Request for Additional Information No. 413(4772), Revision 1, Supplement 3

U. S. EPR Standard Design Certification

SRP Section: 07.08 - Diverse Instrumentation and Control Systems

**QUESTIONS for Instrumentation, Controls and Electrical Engineering 1
(AP1000/EPR Projects) (ICE1)**

Figure 07.08-21-1 —S-RELAP5 One-Dimensional Nodalization Scheme

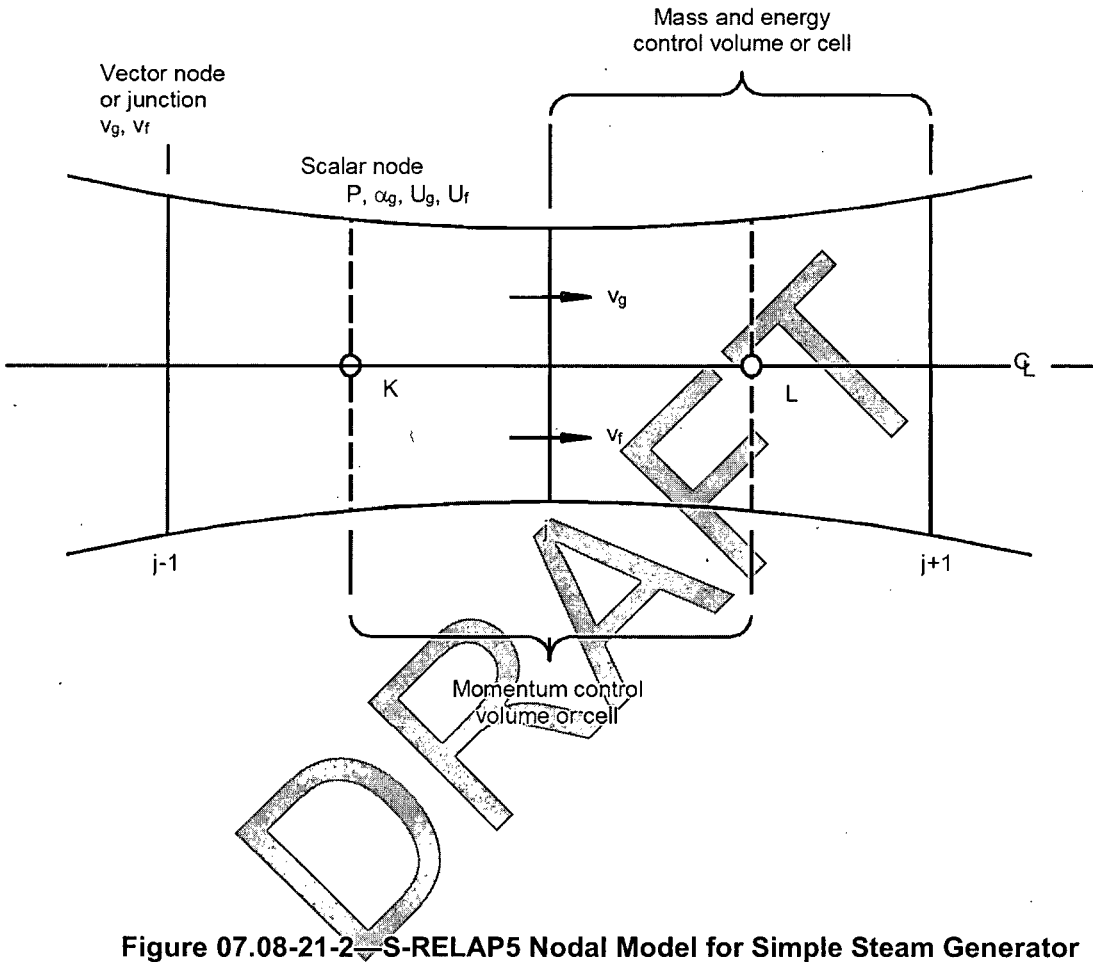
Provide additional explanation of the changes made to S-RELAP5 as utilized for the D3 analysis presented in ANP-10304 Rev 1, including the following:

- a. A description of Heat Transfer modifications (i.e., fluid temperature, Inayatov multiplier, LIQHTC) made to the S-RELAP5 code and the purpose of the change, and
- b. The validation basis for Tavg change made to the S-RELAP5 code.

The original S-RELAP5 heat transfer computation from the wall to the fluid is based on the fluid nodal temperature adjacent to the surface of the heat structure. Figure 07.08-21-1 shows two scalar nodes that are the fluid control volumes for mass and energy. Temperatures are shown

at scalar cell centers, with, T_K on the left side and T_L on the right. The heat transfer from a heat structure adjacent to Node L uses T_L , but, that temperature is actually assigned to the nodal boundary (exit), so, if the flow is from the left-to-right, T_K is assigned to j and T_L is assigned to $j+1$.

A more accurate temperature for computing wall heat transfer is to use an average of the assigned temperatures for the fluid node facing the heat structure. That change is implemented as an option in S-RELAP5 for best estimate non-LOCA analysis.

**Figure 07.08-24-1 — Diversity and defense-in-depth (D3) Secondary System
Nodalization**

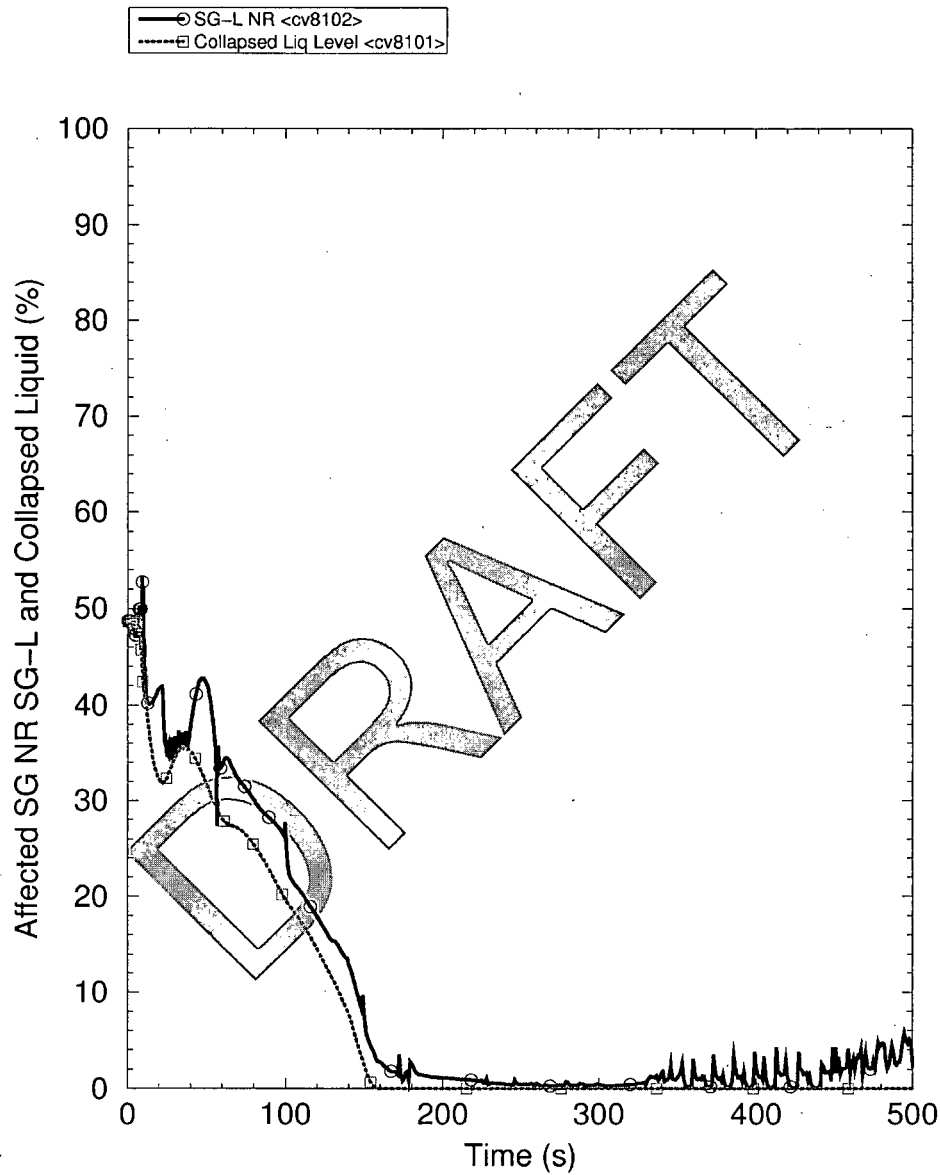
Provide additional information to support the reliability of the predicted DAS trip actuation on Low SG Level, including the following:

For example, using the S-RELAP5 model volume numbers shown in Figure 07.08-24-1 for SG 1:

Figure 07.08-31-1 — Peak Fuel Rod Axial Shapes from NEMO-K and Best Estimate Models

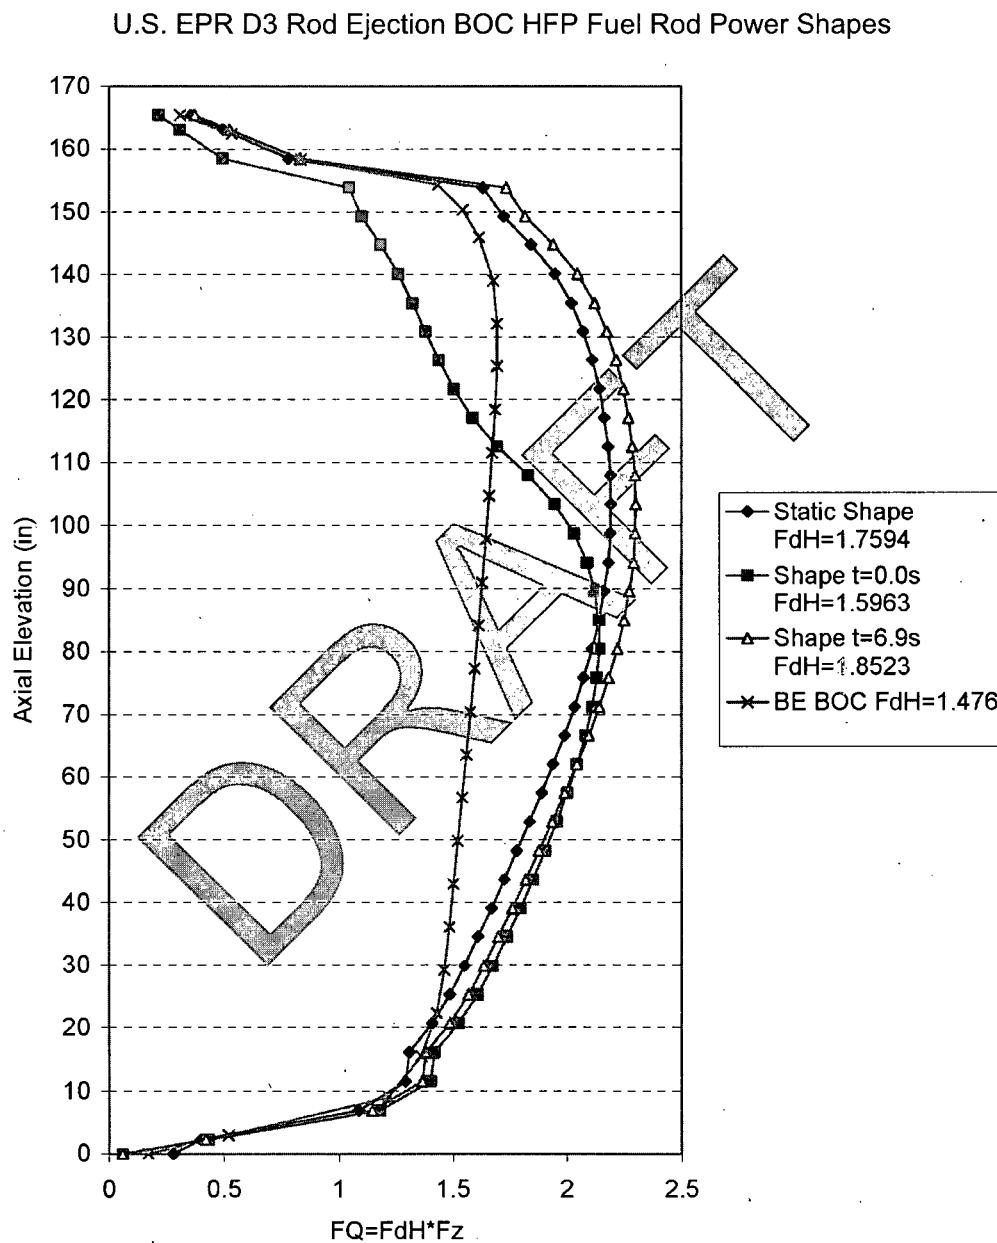
Provide an explanation of difference in the DNBR transient between the no-rupture and with-rupture RCCA Ejection cases described in Section A.3.5.6, including:

The sequence of events for each break size case is provided in Tables 07.08-31-1, 07.08-31-2, and 07.08-31-3. The axial power shapes along with their associated radial peaking factors for the peak fuel rod are provided in Figure 07.08-31-1. The transient shapes are shown for key time points of the transient and are a subset of the full data set from the 3D kinetics calculation. A comparison of the responses for the total core power, the core exit pressure, the core inlet temperature, the minimum departure from nucleate boiling ratio (MDNBR)/specified acceptable fuel design limit (SAFDL), the peak fuel and cladding temperatures, and the peak average enthalpy rise in the fuel are provided in Figures 07.08-31-2 through 07.08-31-6. The information is shown for each case out beyond the time of the MDNBR point. The information shown for each case is beyond the time of the minimum DNBR point. The time ranges presented are from 200 seconds for the no break case to a few seconds after reactor trip for the break cases. The information in the figures allows the following observations to be made.

Figure 07.08-40-5 — Pressurizer Level Response for Various Events

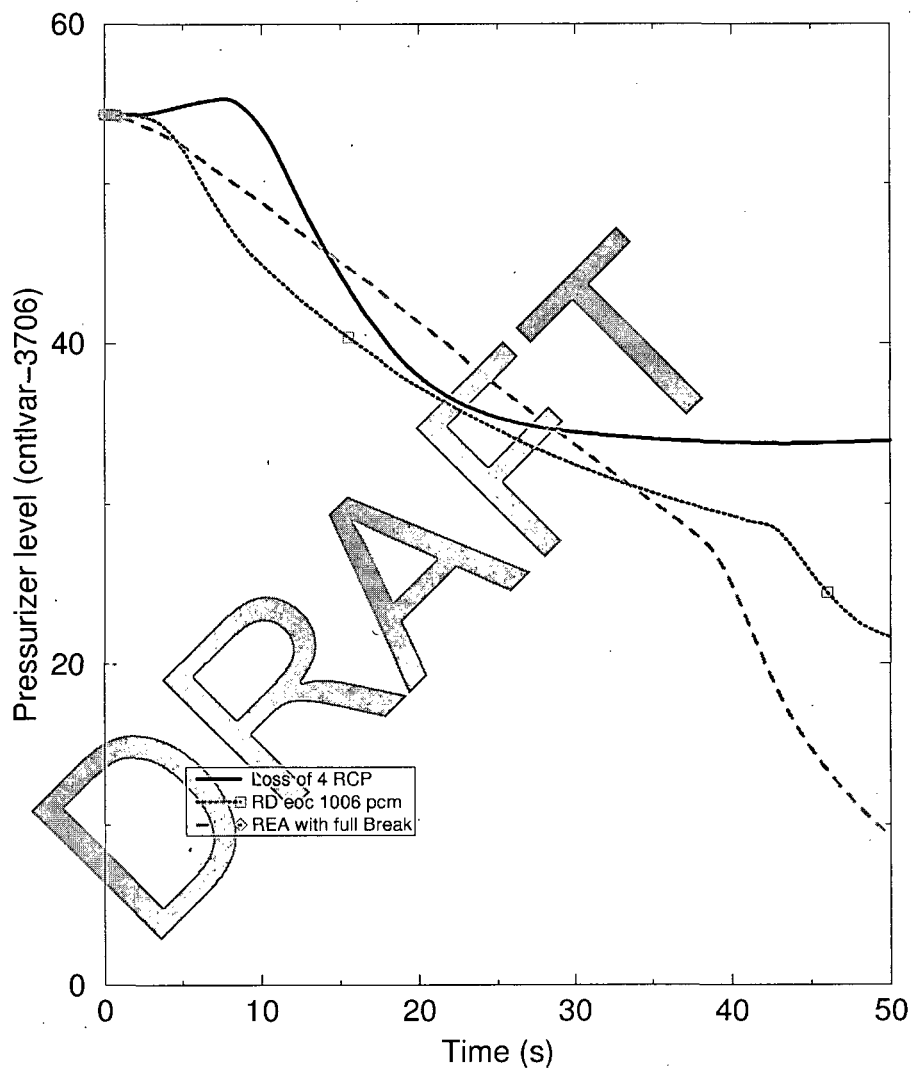
For Section A.2.5 of ANP-10304 Rev 1, describe how the models for pressurizer pressure and level control are validated to assure that they accurately describe the plant response.

Figure 07.08-40-3 and Figure 07.08-40-4 show the CVCS logic that is implemented in the S-RELAP5 models to control PZR level during transients. Figure 07.08-40-5 shows the pressurizer level response to three representative transients:
